ORIGINATION FORM

Proposed Revisions to a Standard Plans Index
(Please provide all information — Incomplete forms will be returned)

Index Number: 700-040
Sheet Number (s): 2 of 5
Index Title: Cantilever Sign Structure

LAST REVISION 11/01/21	REVISION	DESCRIPTION:	 FY 2022-23 STANDARD PLANS	CANTILEVER SIGN STRUCTURE	INDEX 700-040	SHEET 2 of 5
---------------------------	----------	--------------	----------------------------------	----------------------------------	------------------	-----------------

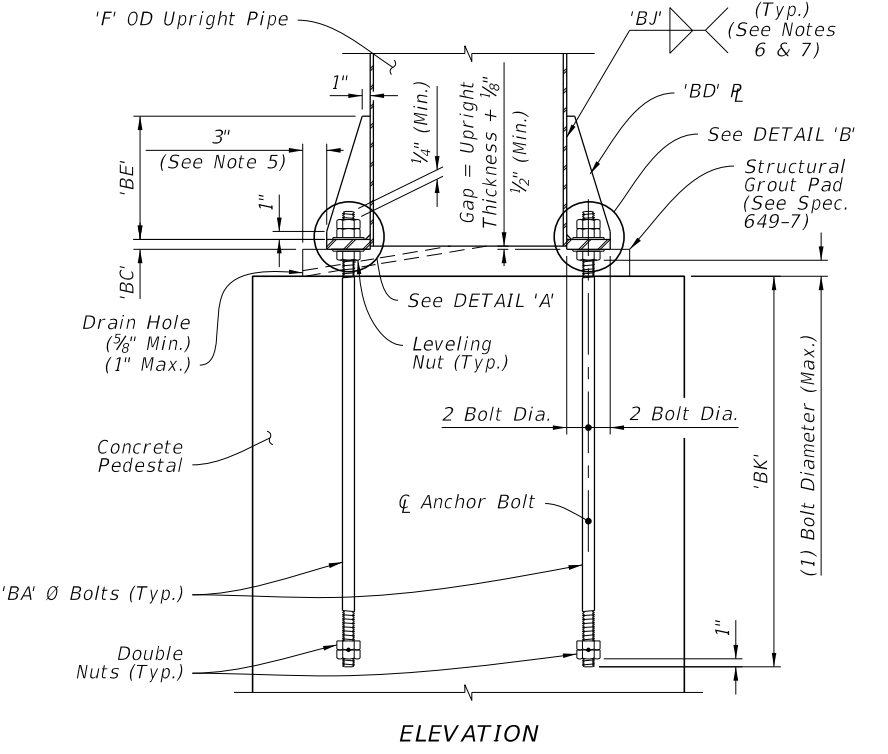
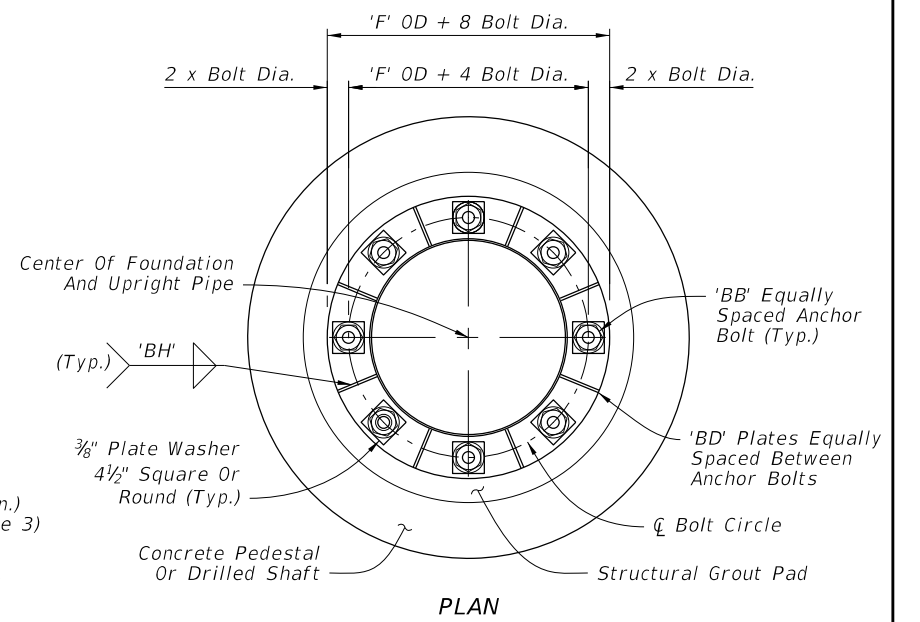
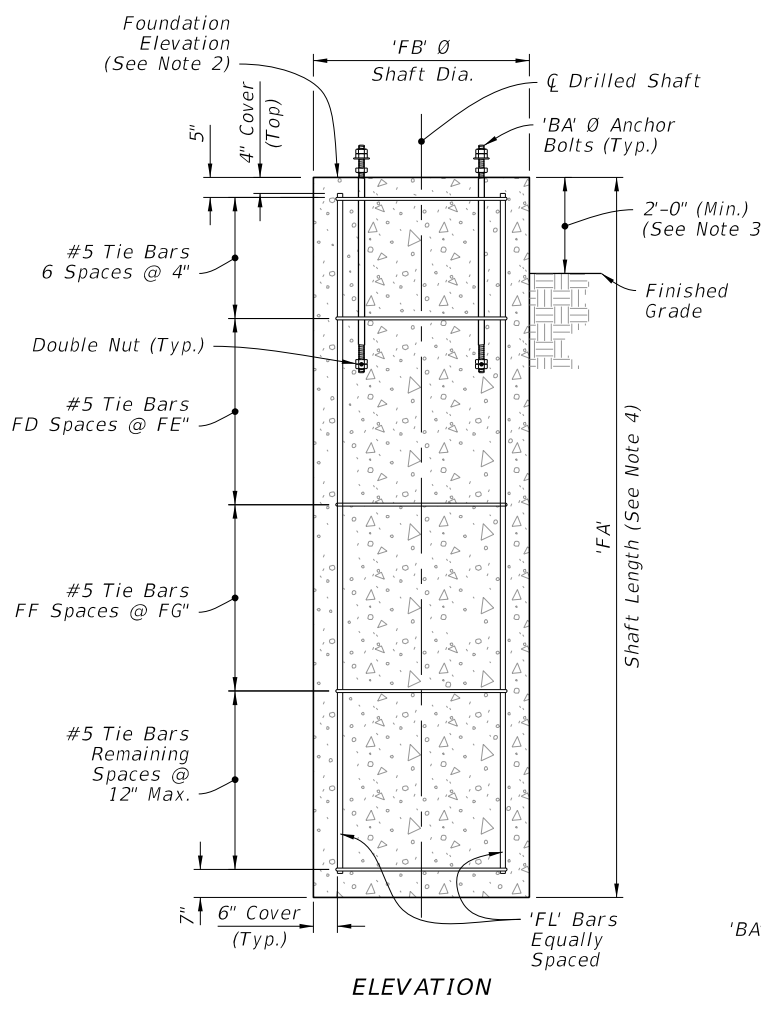
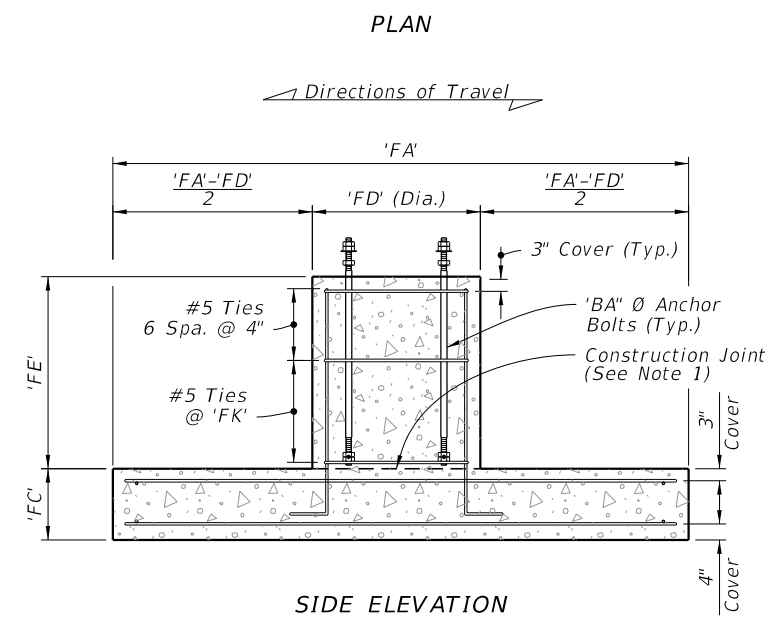
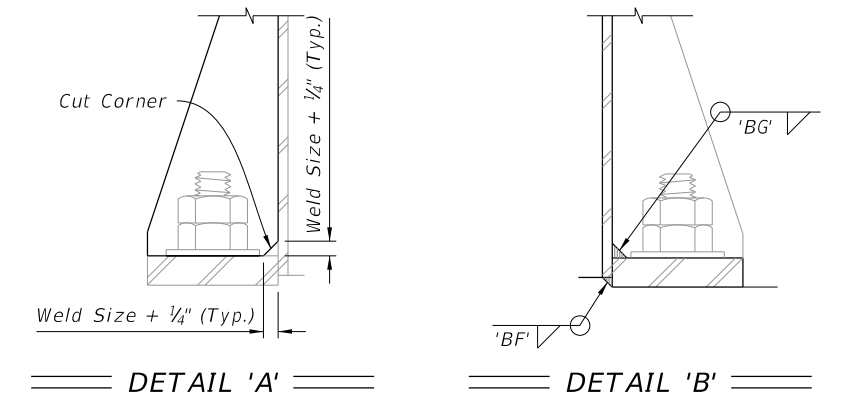
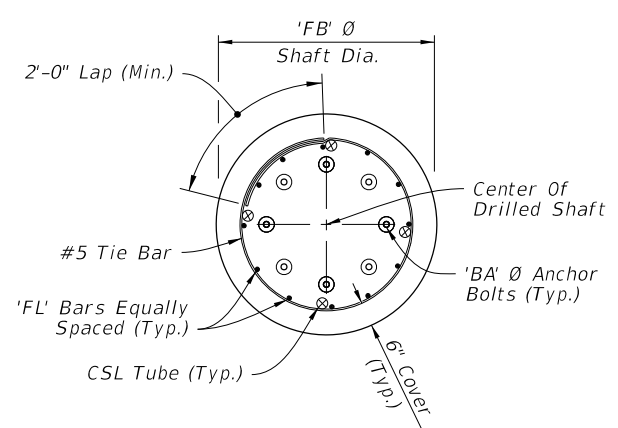
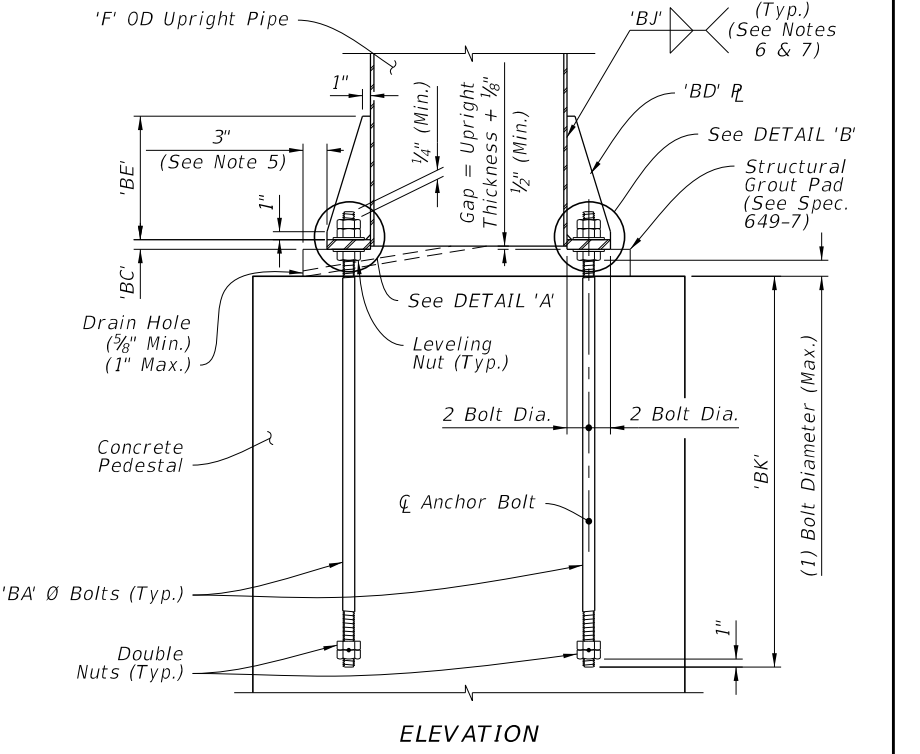
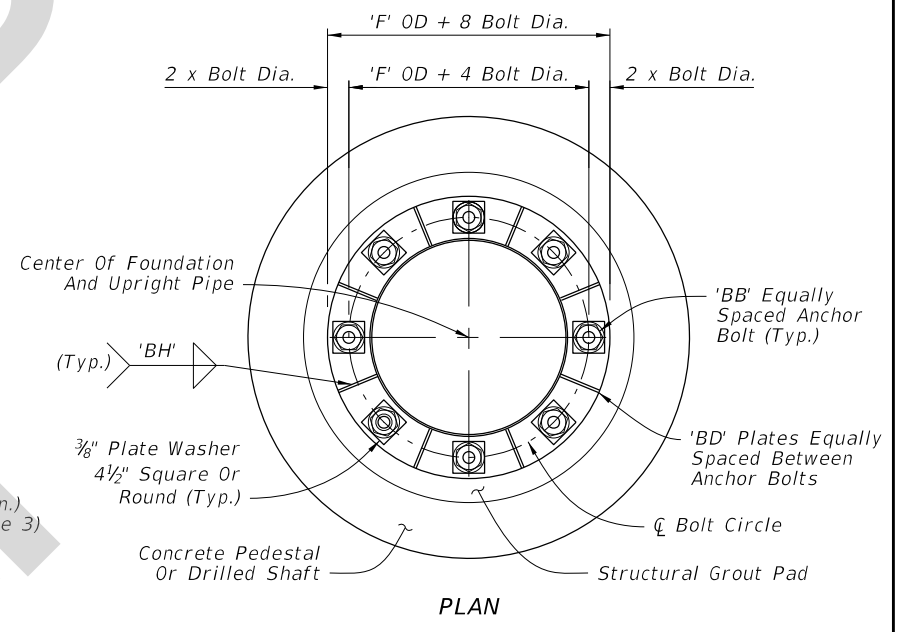
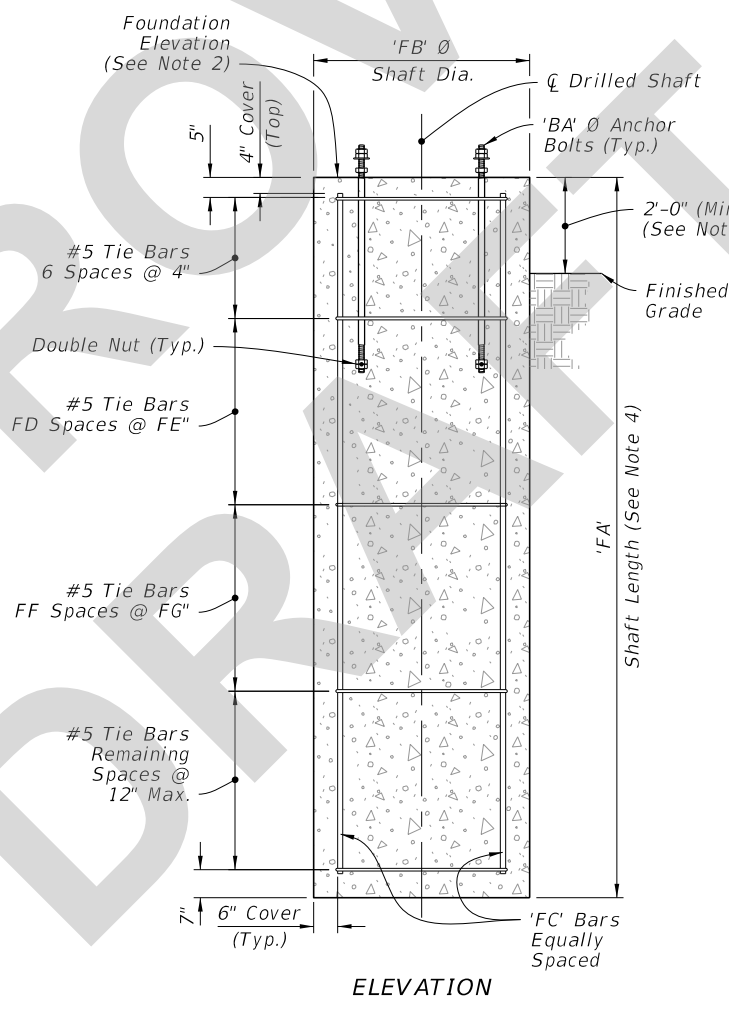
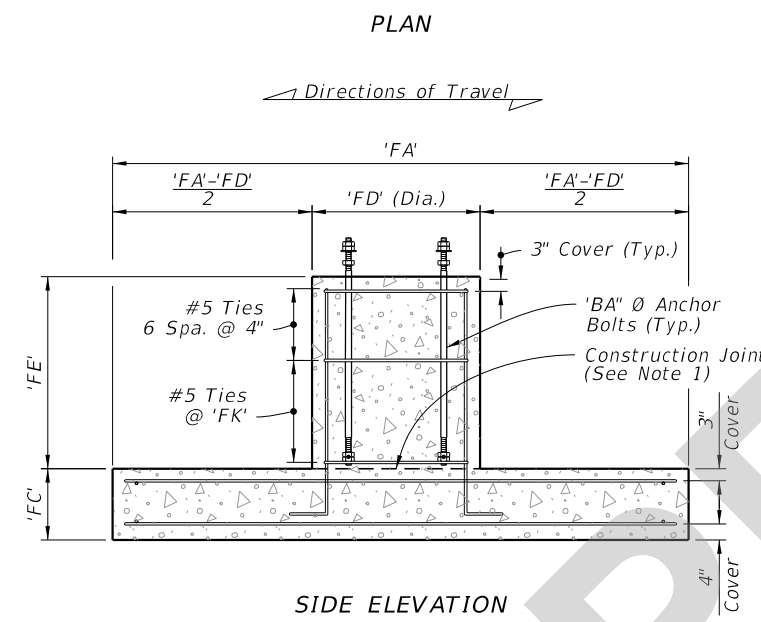
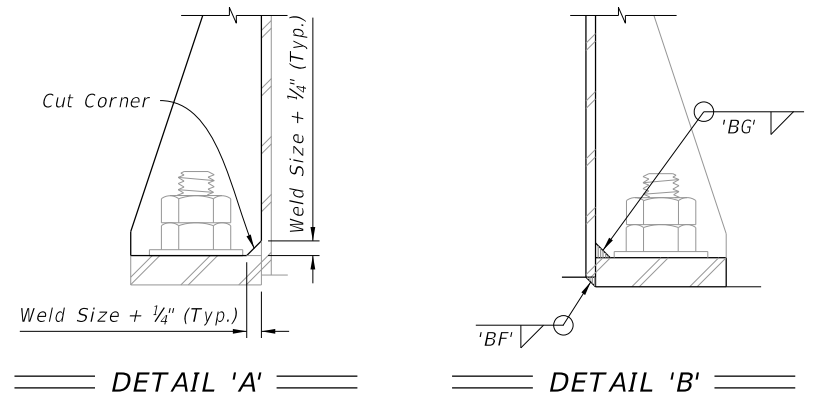
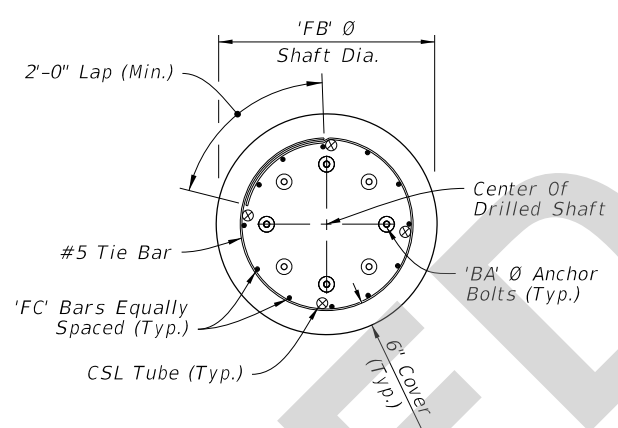
Sheet 2: Changed the 2'-2" lap splice for the #5 tie bars on the spread footing plan view to 1'-8"; Revised Note 5 to read "After galvanizing, provide magnetic particle testing on 100% of upright fillet welds."

Additional Commentary: During maintenance inspections, weld cracks were found on in-service overhead sign structure supports. A FDOT investigation determined the cracks were formed during fabrication. To implement a better fabrication quality control processes, the note on the Standard is being changed.

The reference shown for longitudinal bars is incorrect.

Required lap length for #5 tie bars for spread footing shall be shorter rather than longer than what is required for drilled shaft (2'-0") due to higher concrete strength of spread footing.

After galvanizing, provide magnetic particle testing on 100% of upright fillet welds.
